Eastshore Playground

NRD095 City of New Orleans New Orleans Recreation Development Commission

Design Advisory Committee RE-SUBMITTAL presented by: Chase Marshall Architects 7222 Spruce Street, New Orleans, LA 70118 www.chasemarshall.com

DAC Review Comments 2 SEPTEMBER 2015

SITE PLAN

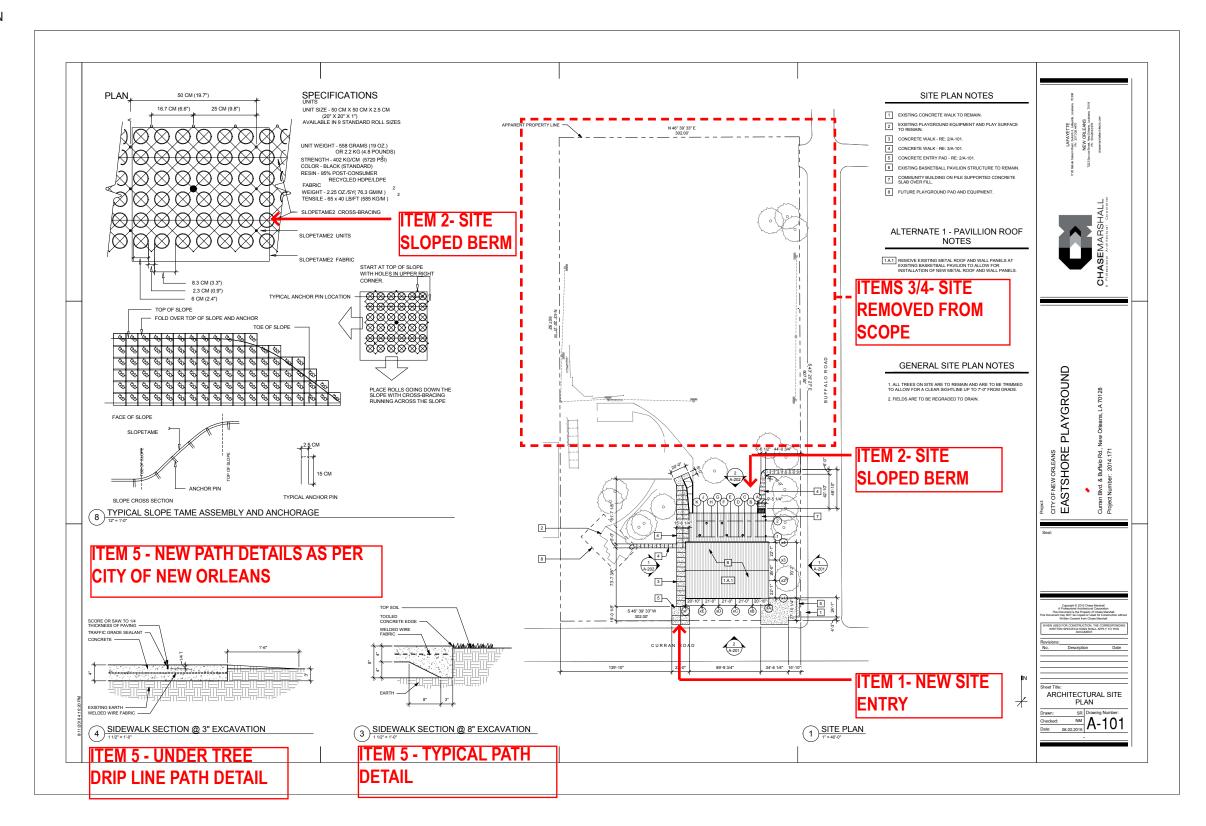
- ITEM 1 o Access to the new playground is not clearly defined and shown on the site plan; ACCESS HAS BEEN REVISED.
- ITEM 2 o The seating around the new playground is not shown on the plan; SEATING SHOWN UNDER BASKETBALL PAVILION AND ON SLOPED BERM

COLORS

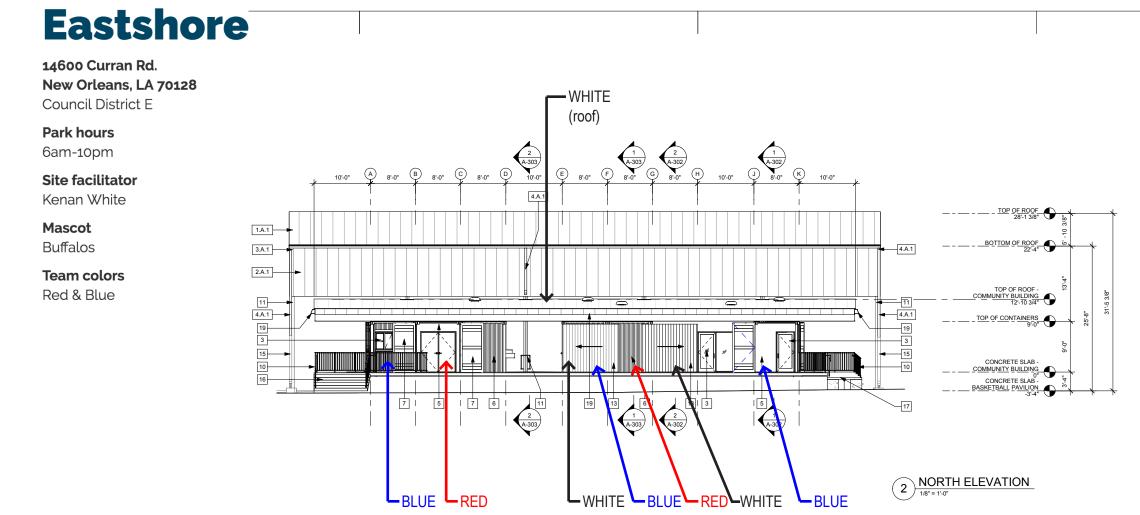
- ITEM 6 The committee members also enquired about the actual colors of the containers. The architect responded that the color on the plans reflects the selection accurately. COLORS ARE AS PER NORDC EASTSHORE TEAM COLORS.

ITEM 6- TEAM COLORS - CONTAINERS ARE TO BE PAINTED NORDC TEAM COLORS ALTERNATING RED/ BLUE.
SLIDING DOORS AND ARCHITECURAL METAL WALL PANELS ARE ICEWHITE
